Appendices Part 6

Comments INDIV-800s Part 2

Comments INDIV-900s

Reponses to Comments

Figure 21. American River Velocity Contours.

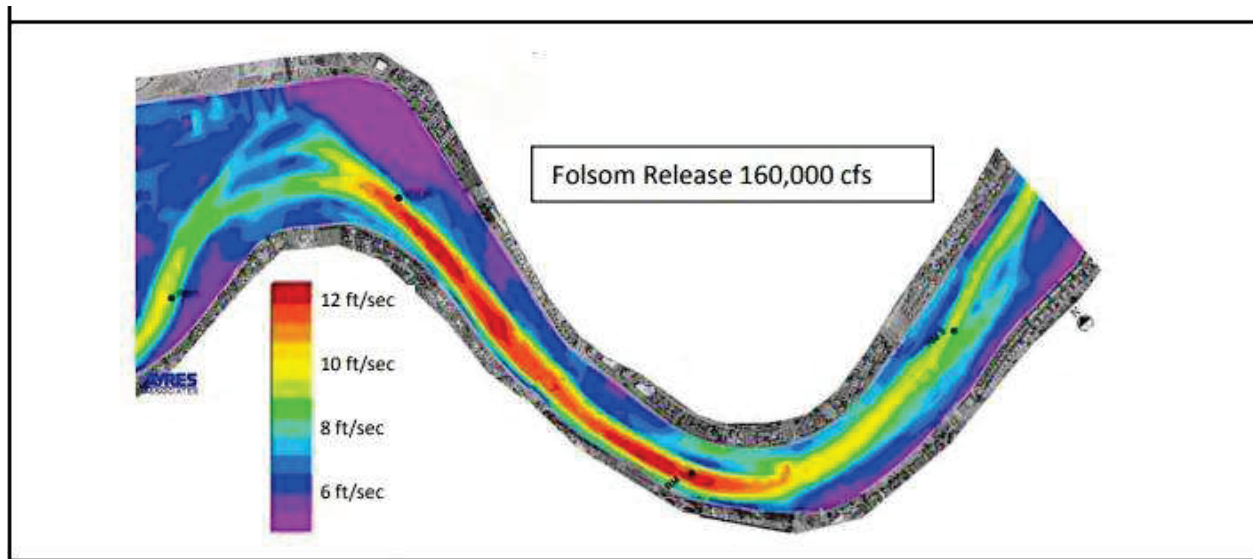
Yet in the appendices for the 2016 Final EIS-EIR, USACE only provided specific velocity data for RM 6 and RM 7.5.

As for the rest of the Lower American River, USACE simply states that average velocities range from 6 to 9 ft/sec.⁴⁷ Even at those velocities, biotechnical and bioengineering measures are feasible. Given that velocities along the banks can vary from 0-12 ft/sec during a 160,000 cfs event, an average velocity for the entire LAR cannot meaningfully justify nor exclude particular measures for particular segments.

Figure 2-8: Velocities in the Lower American River at a discharge of 160,000 cfs

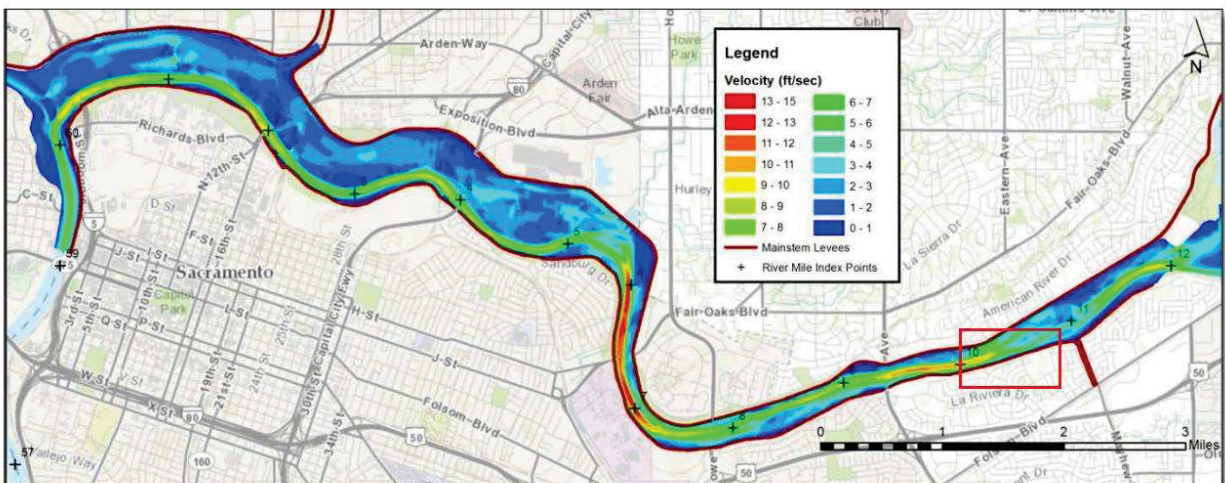
Such observations are consistent with the velocity contour maps in the *General Reevaluation Report*.⁶³ While these maps show that at 160,000 cfs velocities along the some of the LAR’s banks can reach a significant velocity of 12-13 ft/sec, between left bank river miles 10 and 11, which comprises most of Contract 3B South, estimated velocities along the banks during a 200 year, 160,000 cfs event only range from 0-1 ft/sec to 6-7 ft/sec. At these velocities

Figure 1. Bank Protection and Launchable Rock Trench Typical Design.

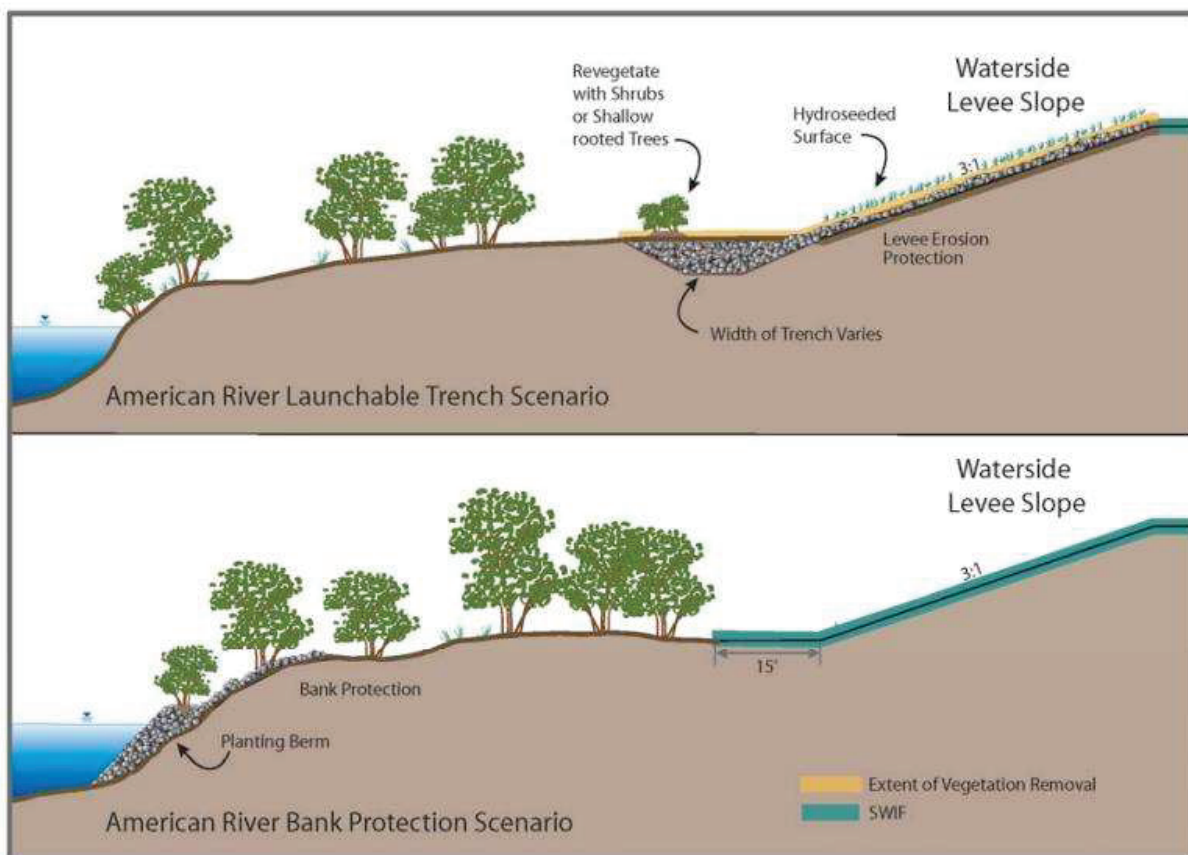
figure 1 of the Final EIS/EIR (figure 4-9 in the *General Reevaluation Report*) shows that tree removal would only occur on the levee itself and at the base of the levee.¹⁰⁰ It indicates that USACE would spare most trees on the riparian bench and on the natural levee slope. For “American River Bank Protection Scenario,” no part of the bank is highlighted for vegetation removal or tree clearing.¹⁰¹ From these diagrams, an apprehensive citizen could reasonably conclude USACE would remove few trees, if any at all, while installing either launchable rock trenches or bank protection.

Figure 3.5.2-9. American River Erosion Contract 3B South Site 4-1 Details

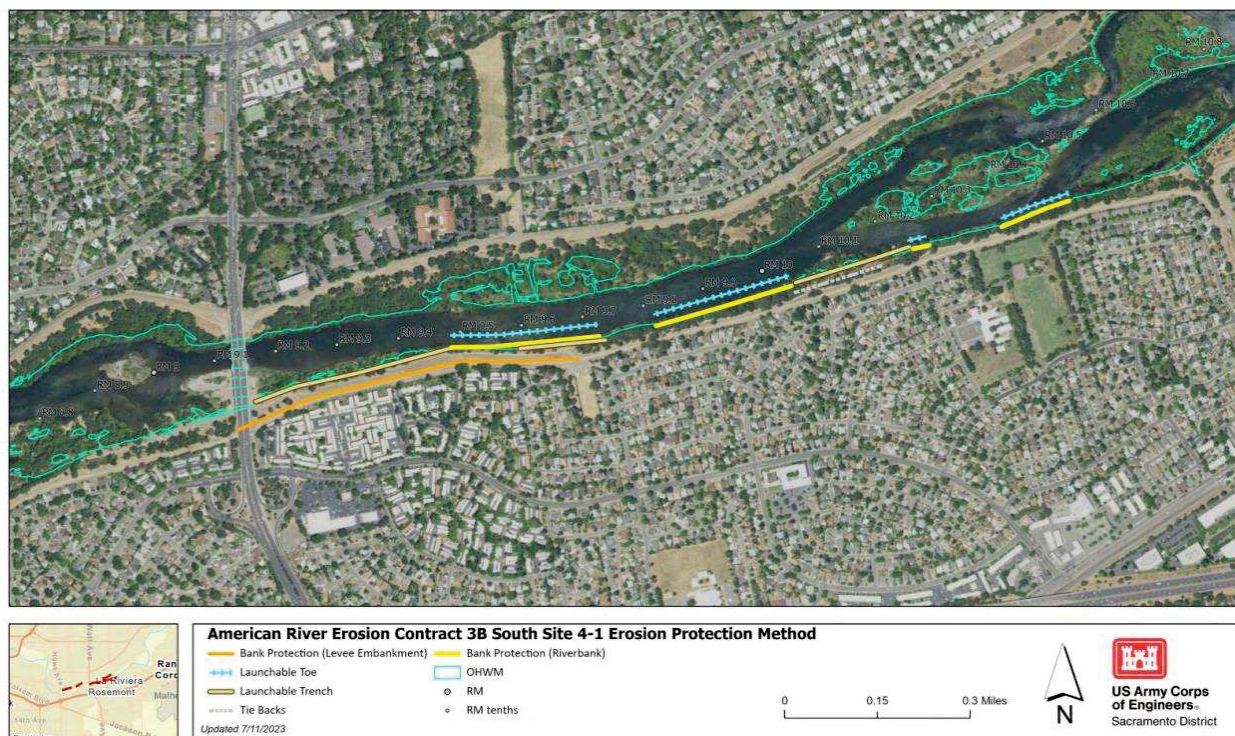
By contrast, the visual projections of USACE’s proposed work for the 2023 Draft SEIS/SEIR are vague and overly generalized.¹¹⁹ Instead of site-by-site diagrams for Contract 3B South, USACE provides a zoomed-out map with lines indicating where launchable rock toes, trenches, and bank protection will be implemented. It is impossible from this visual (figure 27

below) to ascertain any meaningful environmental or recreational impacts. Instead of site-by-site descriptions of soil filled revetments, USACE simply provides figures which illustrate the general concept of launchable rock toes, trenches, and planting benches (see figure 16).¹²⁰ The pictures of American River Contract 1 and 2 already demonstrate that we can expect little resemblance between USACE's conceptual diagrams and the final work.

Figure 32: Diagram from "Care of California's Native Oaks"

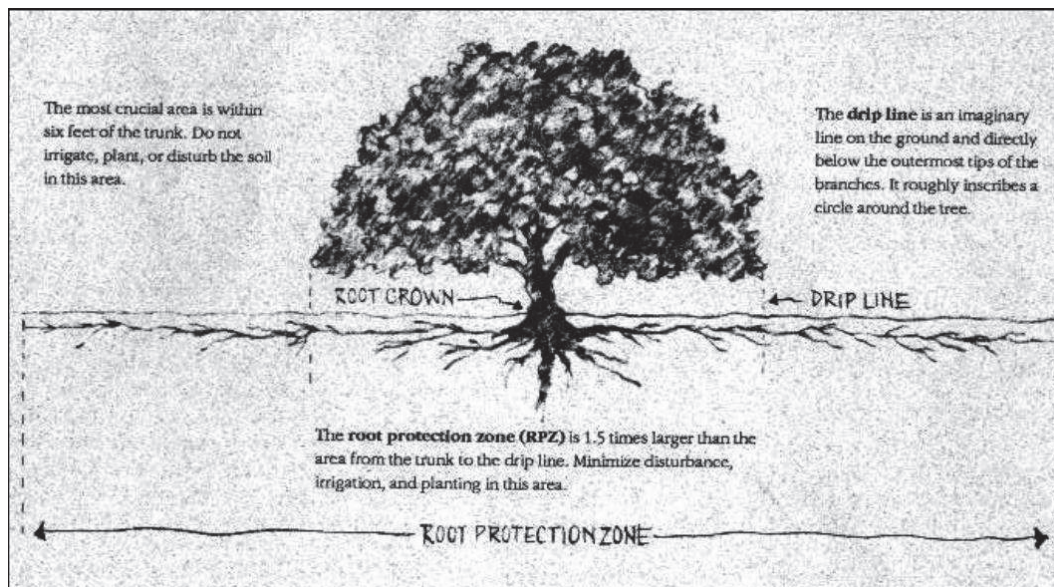
USACE also needs to acknowledge the potential impacts even to heritage trees they plan to "save." It is not enough to simply state whether they will cut down trees. In placing heavy ramps, moving construction equipment back and forth across the banks, and removing most vegetation, USACE's contractors would likely still operate within what the California Oak Foundation calls the "root protection zone" of trees excluded from removal.¹²³ The root protection zone is critical area of an oak tree's roots that is typically 1.5 times the area from the trunk to the dripline.¹²⁴

Figure 33: Heritage Oak Tree near the 2011 revetment project area that dropped all its branches shortly after the installation of the riprap.

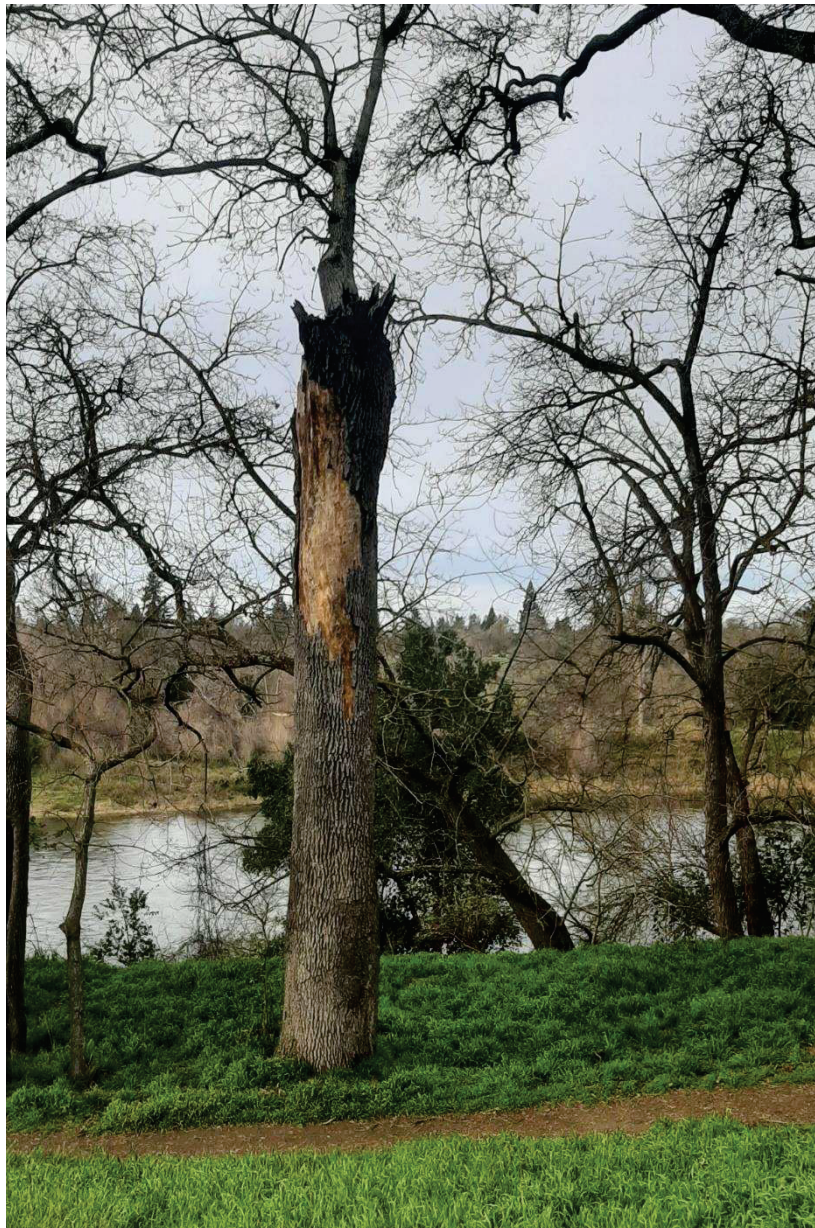
Removing vegetation, trenching, or compacting the soils (through, for example, the movement of diesel trucks near trees) can kill or greatly reduce the remaining life expectancy of an oak tree even if the visible parts of the tree remain unscathed immediately after project completion. Indeed, some of the heritage oak trees near USACE's 2011 revetments at left bank river mile 10.3-10.4 died or lost most of their branches shortly after USACE finished installing the riprap. USACE should explain how they will install erosion measures without encroaching on the root protection zone of beloved heritage trees.

**Figure 32. Contract 3B Tiebacks**

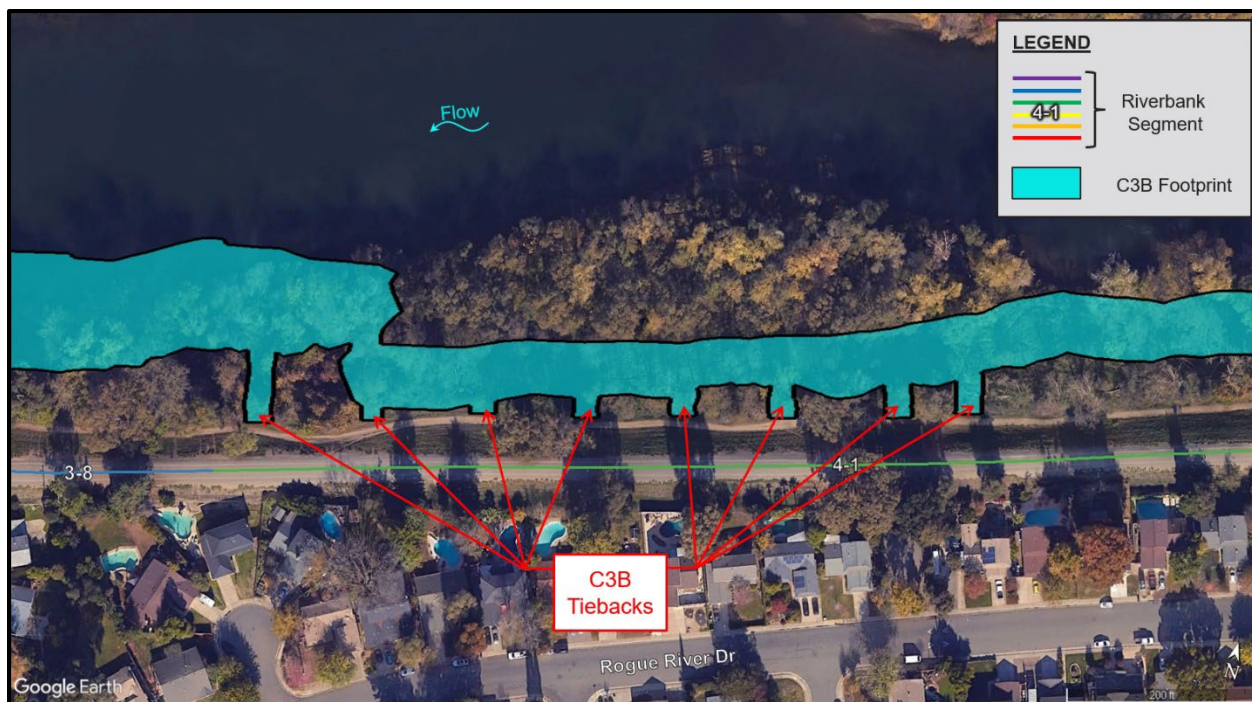
Within Contract 3B Segment 4-1 on the south bank of LAR, upstream of Watt Avenue, part of the erosion protection planned includes installation of rock tiebacks which serve to prevent erosion from outflanking the revetment installed at the riverbank's edge (i.e., eroding the bank/levee landward of the riverbank's edge revetment). These tiebacks can be seen in Figure 32 below. The locations of these tiebacks were selected to avoid impacts to existing vegetation and were intended to extend further landward into the VFZ to ensure the tiebacks ability to prevent erosion from outflanking the Contract 3B bank revetement; however, due to concerns which arose late in the design development phase of Contract 3B the tiebacks were cut short to avoid encroaching into the vegetation free zone. The concerns were specific to working in and around the vegetation which exists within the VFZ which could trigger the need for, and USACEHQ approval of, a VDD. Given the time requirements to develop and get approval of a VDD, as further described in Section 2.4 above, it was decided to stop the Contract 3B tiebacks outside the VFZ and construct the remaining extent of the tiebacks under Contract 4B which was already planning on developing a VDD to support preservation of trees identified as a lone tree scour risk described in Section 2.

The Contract 3B tiebacks are fully buried and constructed using soil filled rock. For Contract 4B, the eight tiebacks depicted in Figure 32 above will be extended further landward and be constructed in the same manner as Contract 3B. The exact length of each tieback extension is still being determined but the tiebacks will extend into the VFZ and into the levee embankment. A typical cross section of the tiebacks is shown in Figure 33 below. A rough estimation of the extended tieback footprints is shown in Figure 34 below.
